VARIANCE APPLICATION SUMMARY

| Project/Business Name | Gahanna Logistics Center |

Re: Proposed Gahanna Logistics Center
Tech Center Drive, Gahanna OH
Permit App DP-25-1
Variance Request Statement V-25-11 – Revision 1

PLANNING COMMISSION STAFF REPORT

SIGHTLINE STUDY - TAYLOR RD. (A)

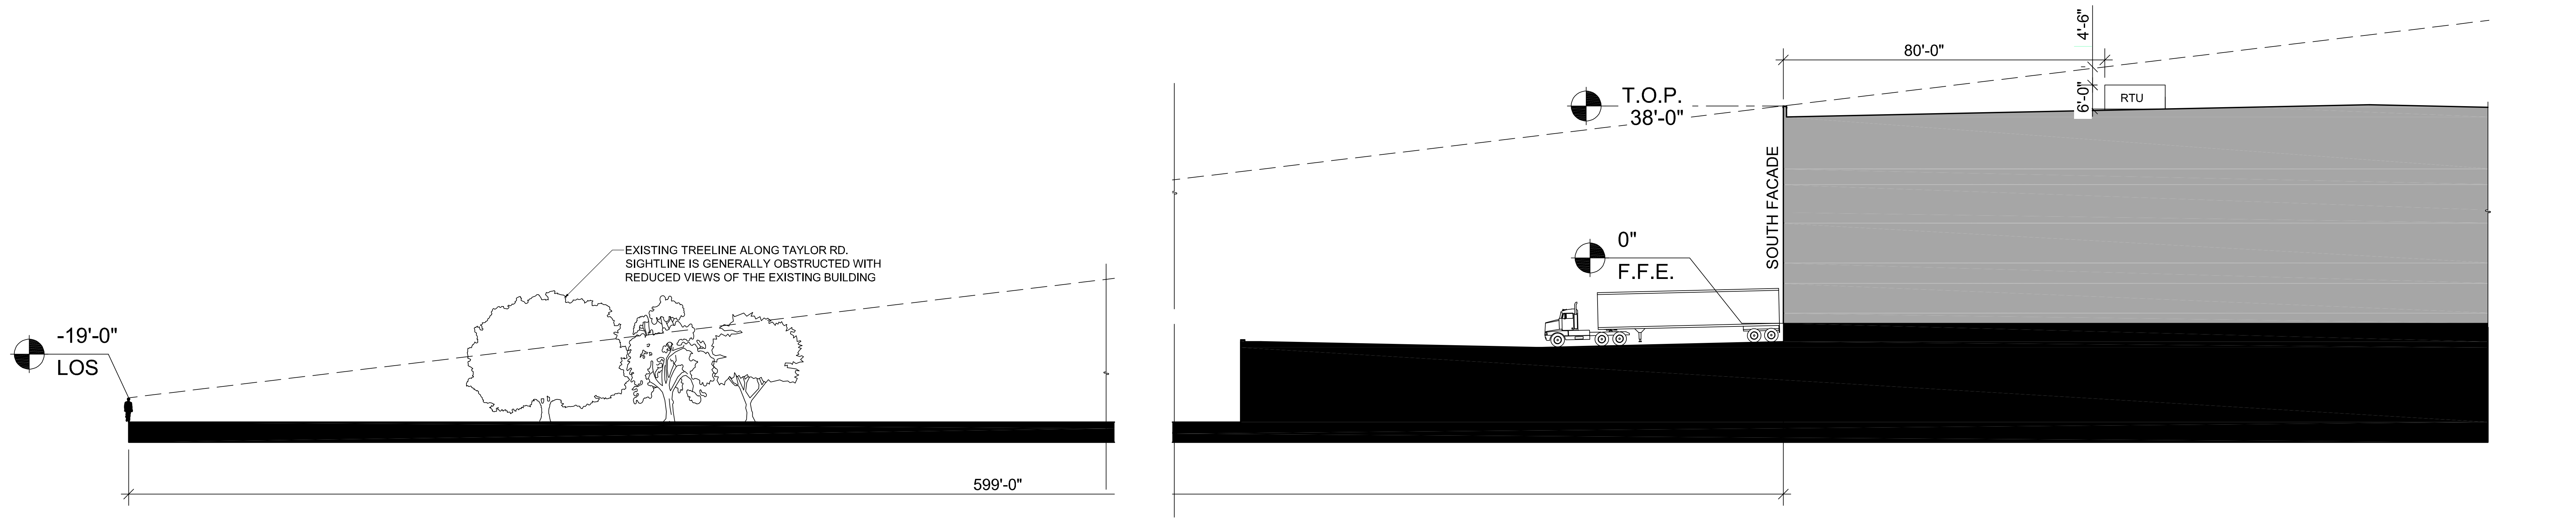
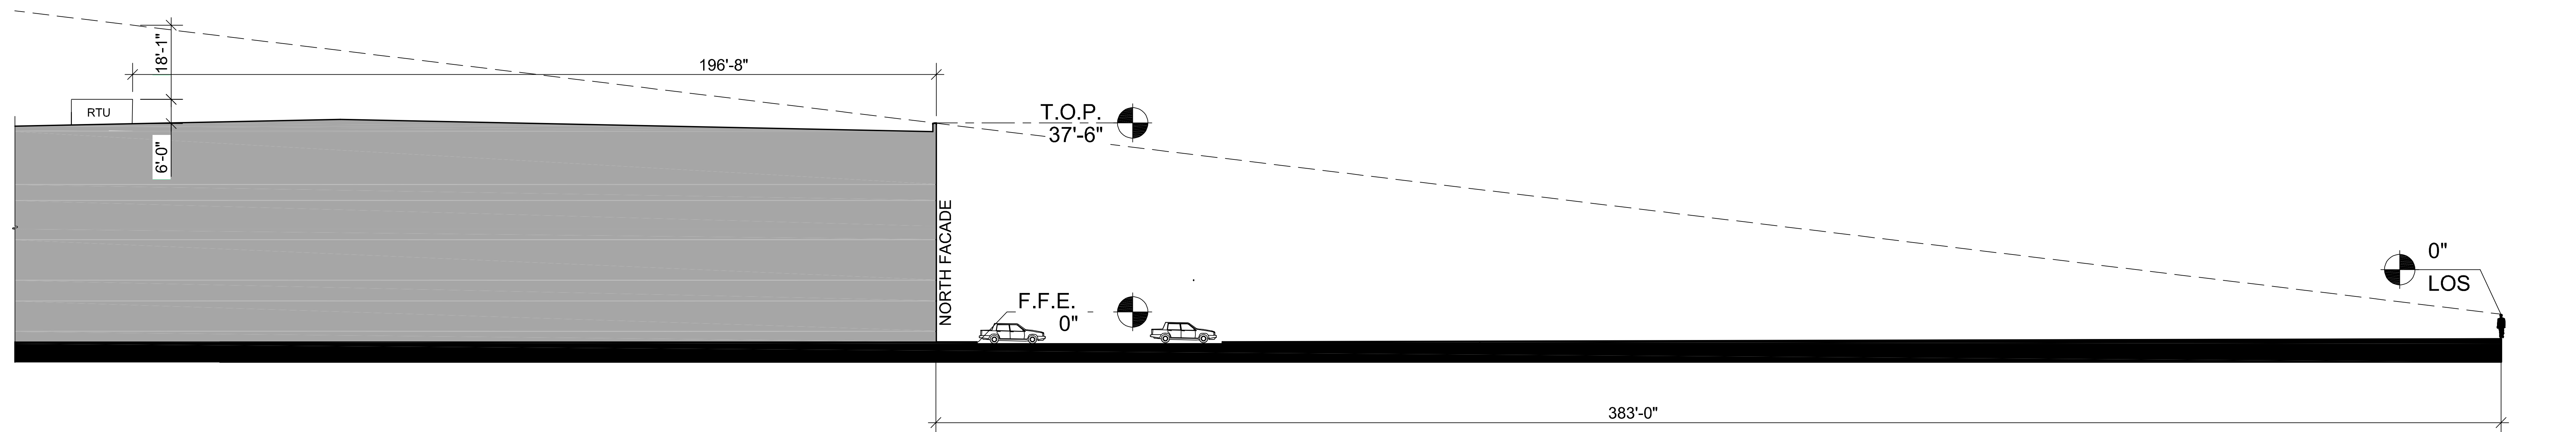
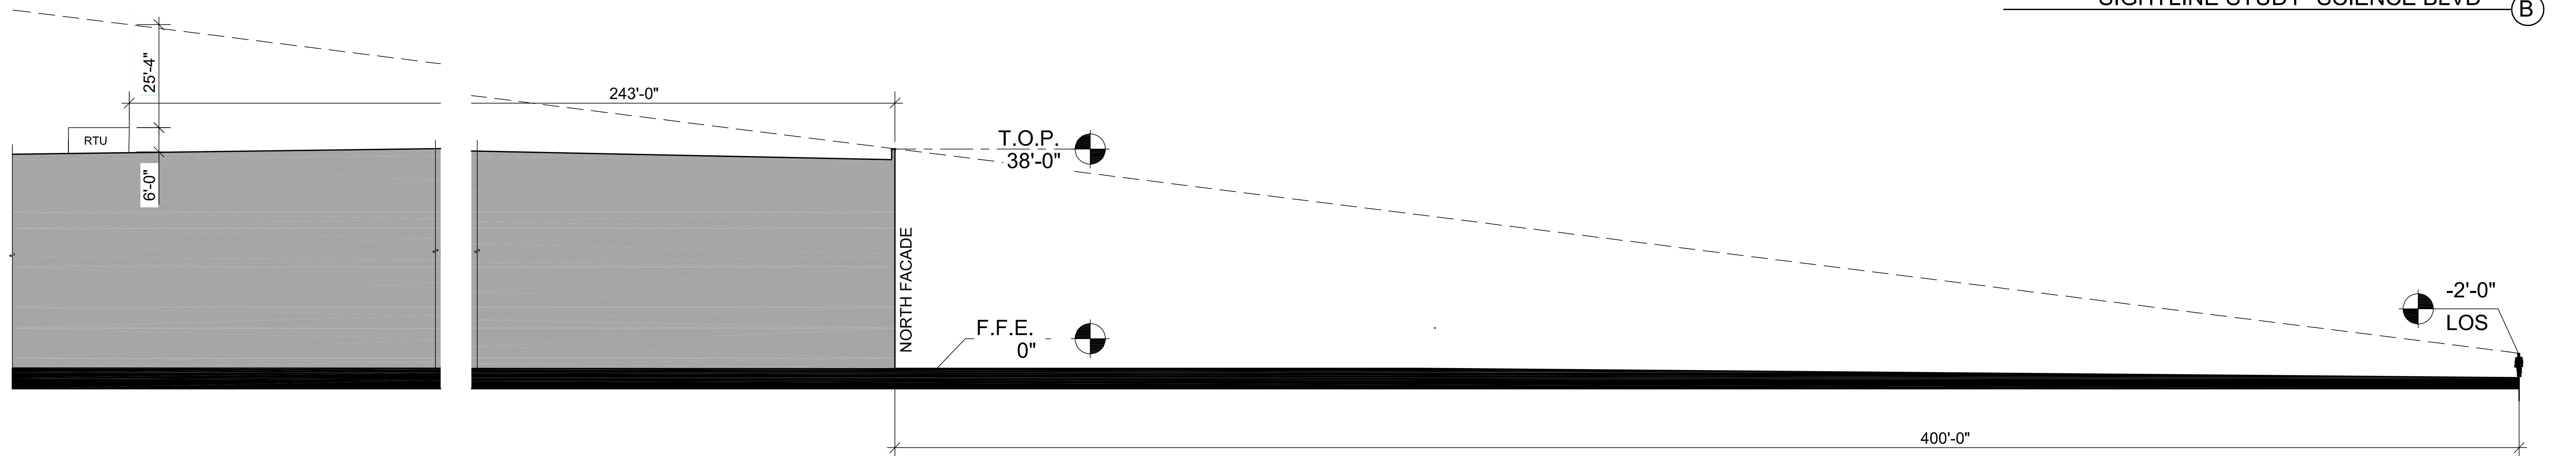
6. Central Park Overlay provision 5(B)(1)(a) requires a 2' minimum parapet as needed to screen rooftop equipment and provision 5(B)(2)(e) calls for clustering of the equipment as well as individual screening at the units. **We request relief from these Overlay provisions as the three rooftop units for this project will not be visible from surrounding properties as illustrated by our line-of-sight study.**

- i. The line of sight study illustrates that raising parapet height or screening at the units isn't necessary for the units to be hidden from view from adjacent properties.*

- b. The applicant has provided a site of line study that shows that the rooftop equipment is virtually hidden from all directions.

- c. No objections from staff. The site line study shows minimal visibility, if any from surrounding properties. Additionally, the variance has been granted for similar projects, even in cases where the rooftop equipment was more visible.

BUILDING ELEVATIONS - NTS

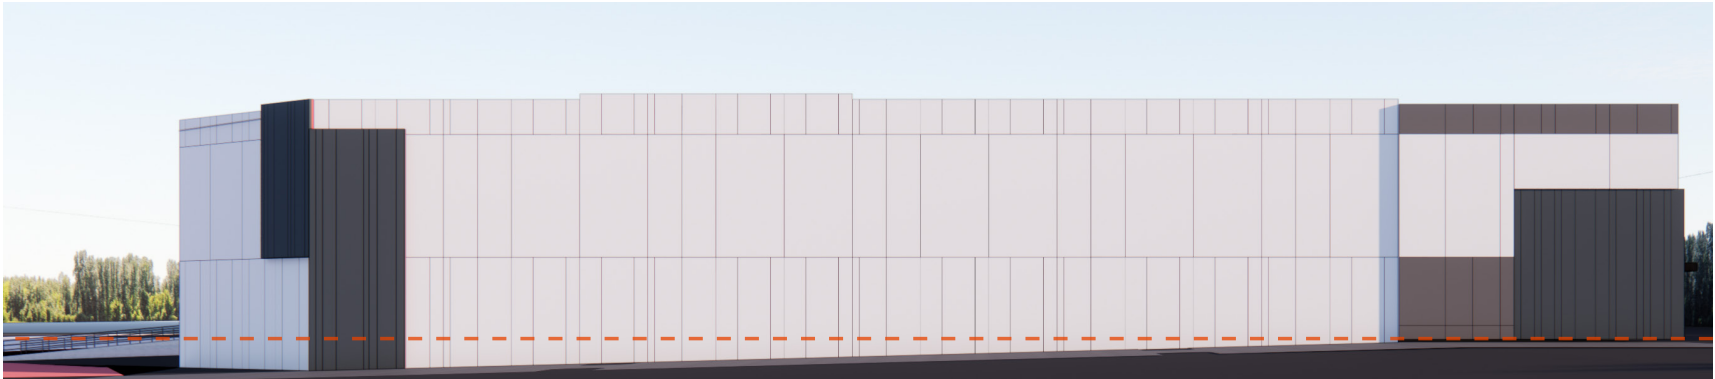
5. Central Park Overlay provision 5(A)(3) requires that the main façade incorporate 50% brick or stone. **We request relief from this provision on the basis of aesthetic clash, marketability, and design precedent set by neighboring developments.**

- i. The overall design theme of this building is Mid-Century Modern architecture, emphasizing simplicity, clean lines, functional forms, and the honest expression of structure and materials. Rather than relying on traditional, heavy materials like brick or stone, this style often features exposed structural elements such as steel and concrete, and smooth, unornamented surfaces that convey modernity and efficiency.*

- a. Main façade shall be 50% brick or stone.
 - b. The applicant provides that design theme, Mid-Century Modern, emphasizes simplicity and clean lines rather than utilize heavy materials such as brick or stone.

- c. Staff has worked with the applicant to refine the design of the buildings while respecting the architectural design of the project. The applicant modified the design of the project by incorporating design elements of surrounding projects, specifically Burns and Scalo and ADB Safegate. Please see the final page of the staff report for images of Burns and Scalo and ADB Safegate.
